Cowling Details and Installation

Drawing Scale	Drawing Number	Revision
1:8 & Noted	ONX-P02	A

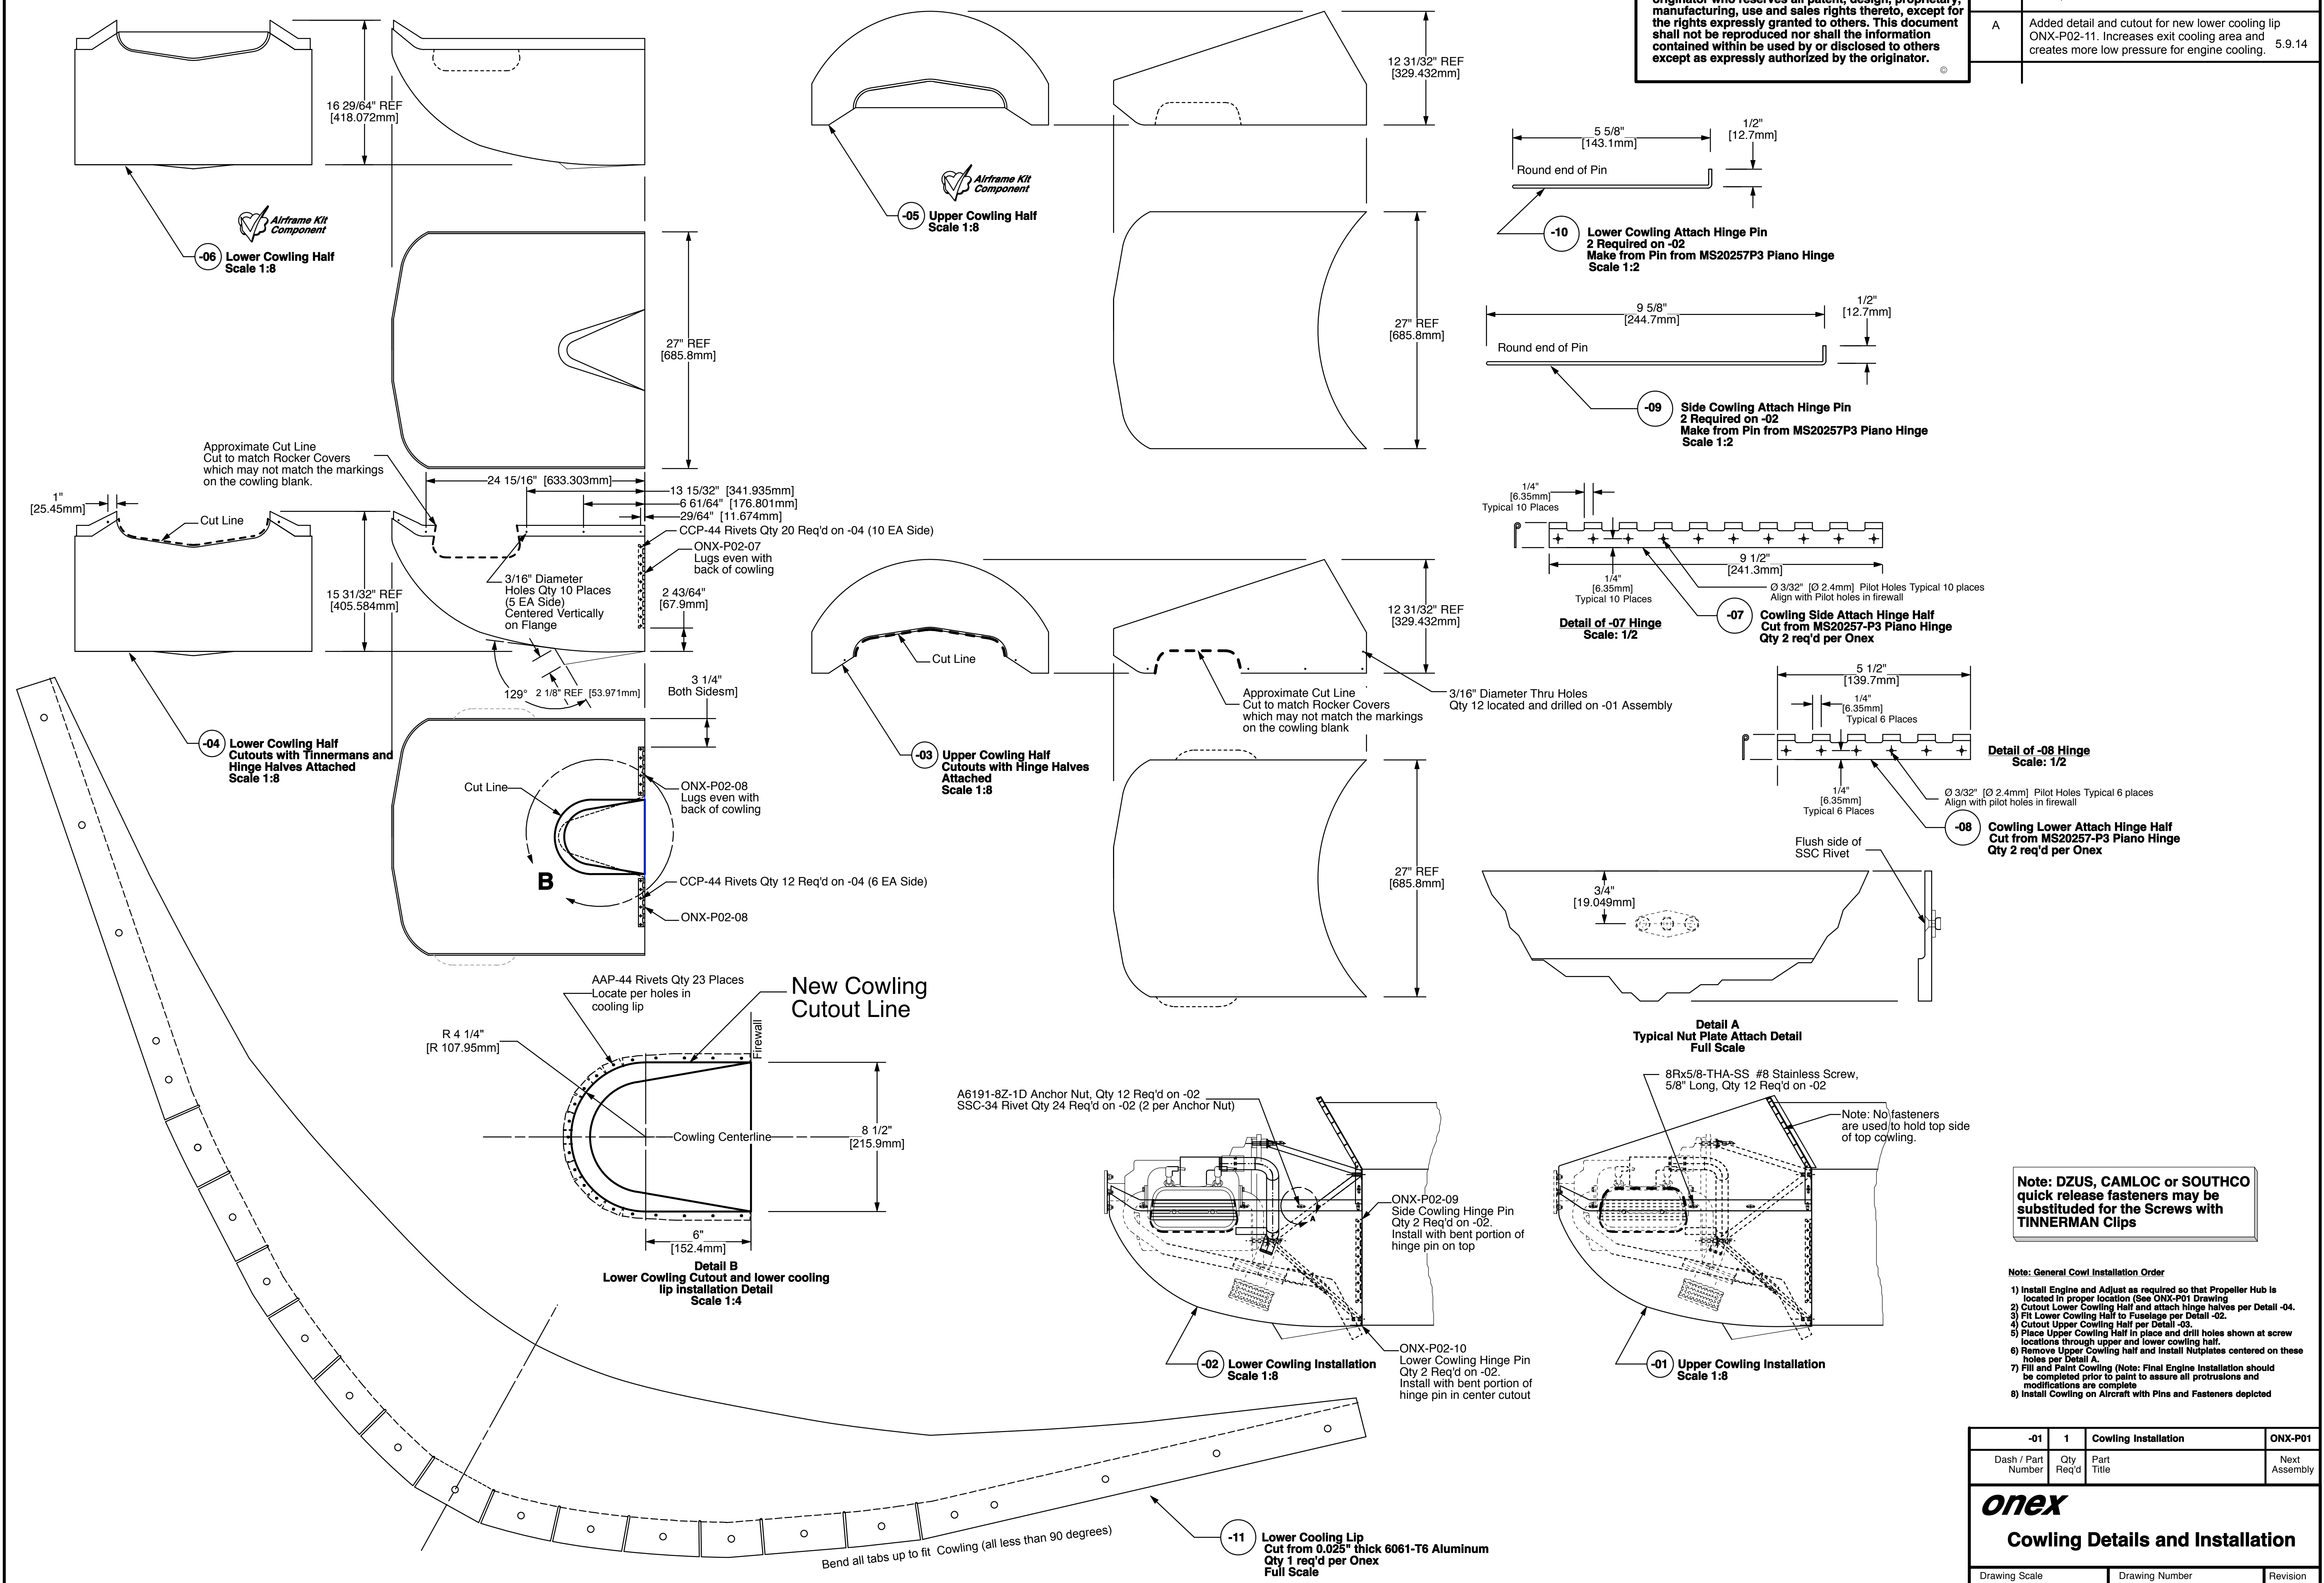
Revision Letter	Change Description
A	Added detail and cutout for new lower cooling lip ONX-P02-11. Increases exit cooling area and creates more low pressure for engine cooling. 5.9.14
